NUCLEAR ENERGY INSTITUTE

**SUBJECT:** Response to Questions on Addendum 2 to EPRI Performance  
Prediction Methodology Software, Version 2.0

**Project Number: 689**

**Responses to NRC Comments on  
Addendum 2 to EPRI TR-103237-R2**

**Figure B-1.** Prediction Ratio (PR) versus Allowable Rate-of-Loading (ROL) for Cold Water Strokes

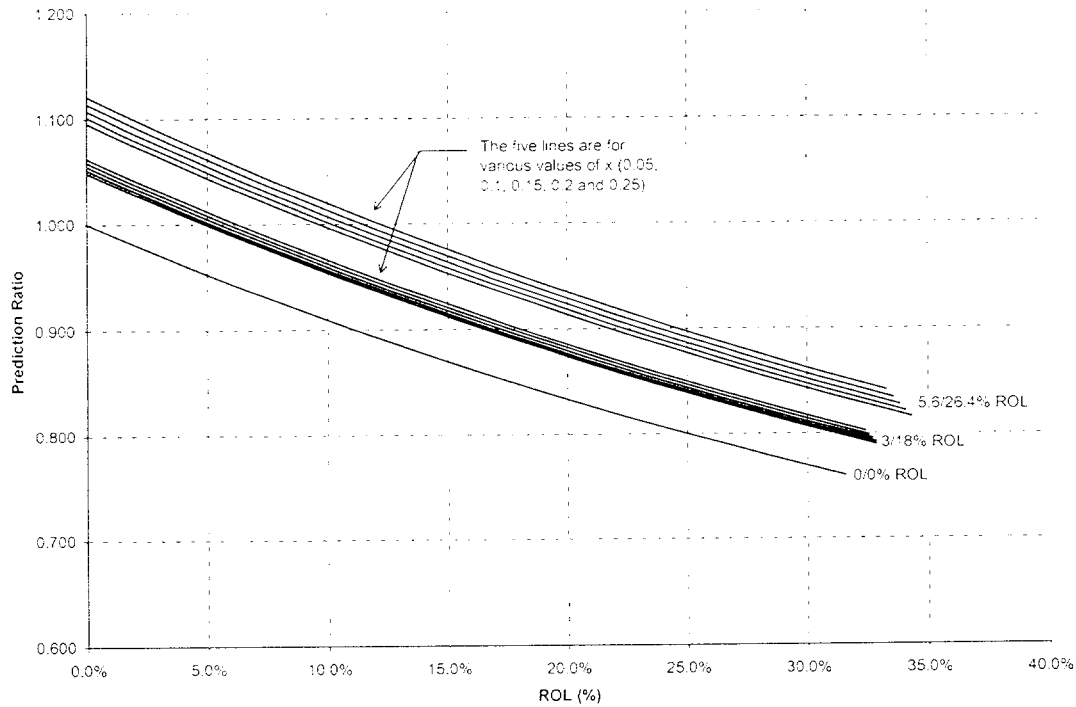
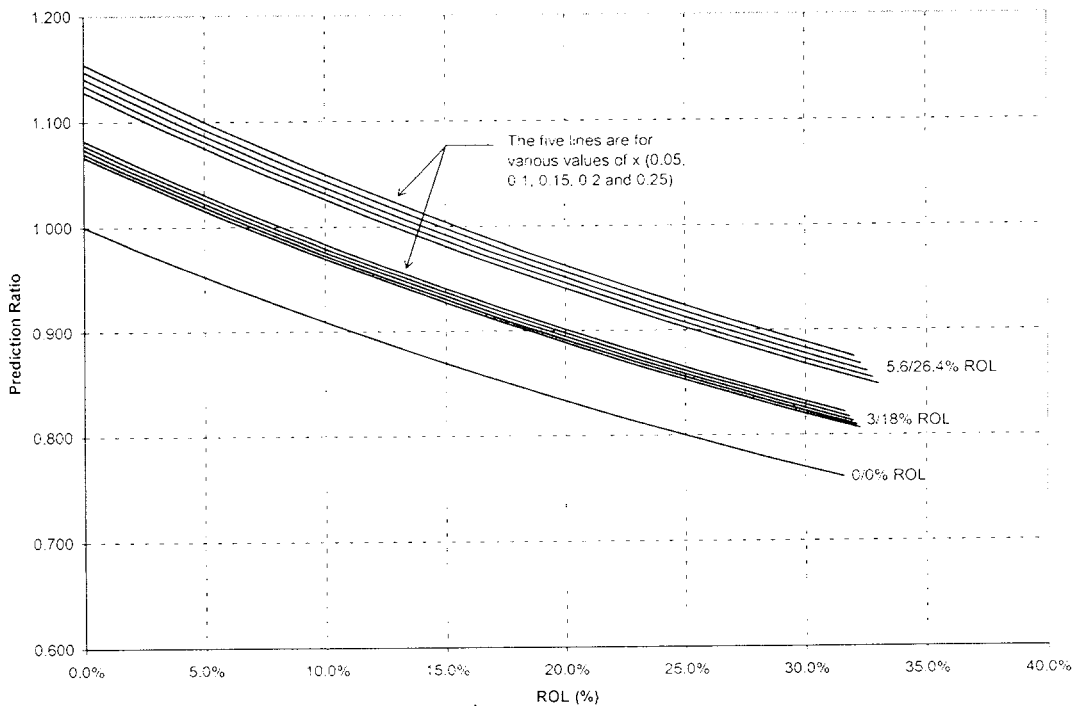
Explain the basis for comparing a prediction ratio based on dynamic thrust predictions from the EPRI MOV PPM to a prediction ratio based on thrust predicted to be delivered at torque switch trip (including random and bias uncertainties) to support the Thrust Uncertainty Method.

Figures B-1 and B-2 plot PR versus available  $\text{ROL}_{\text{margin}}$  for ROL values of 5.6/26.4%, 3/18% and 0/0% bias/random, for cold water strokes and hot water strokes, respectively. The five different lines for 5.6/26.4% and 3/18% ROL correspond to  $x$  values of 0.05, 0.10, 0.15, 0.20 and 0.25. These plots use the  $T_{\text{CST}}/T_{\text{PPM}}$  values shown in the table above. Using the example above, if  $x = 0.15$ ,  $\text{ROL} = 5.6/26.4\%$ ,  $\text{APR} = 0.697$  (cold water) and PR is 0.9, the amount of ROL that can be tolerated is 23.1%, as shown on Figure B-1.
